GOVERNMENT OF MADRAS.

LOCAL AND MUNICIPAL DEPARTMENT.

I have the honour to forward herewith plans and estimates in connection with a water-supply scheme for the town of Coimbatore.

Water-supply Scheme.

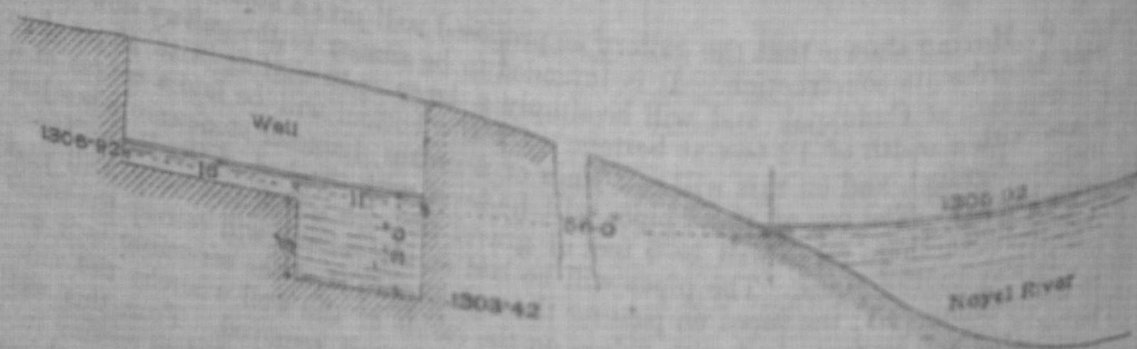
7. It is proposed to obtain the required supply from a filter gallery cut along side and parallel to the river, and in view of determining the length of this gallery experiments were made by pumping from a well or square tank which is at the site. The section of the well is thus—

The well was baled out completely twice and under the conditions in sketch rose in one experiment 3' 6" and the other 5' 5" in 12 hours. These experiments were made on 3rd and 12th June 1891, the driest time of the year. The length of the tank is 36 feet, so that the quantity of water with a maximum head of 5' 6" and an average of 1' 9" filtered into the tank was—
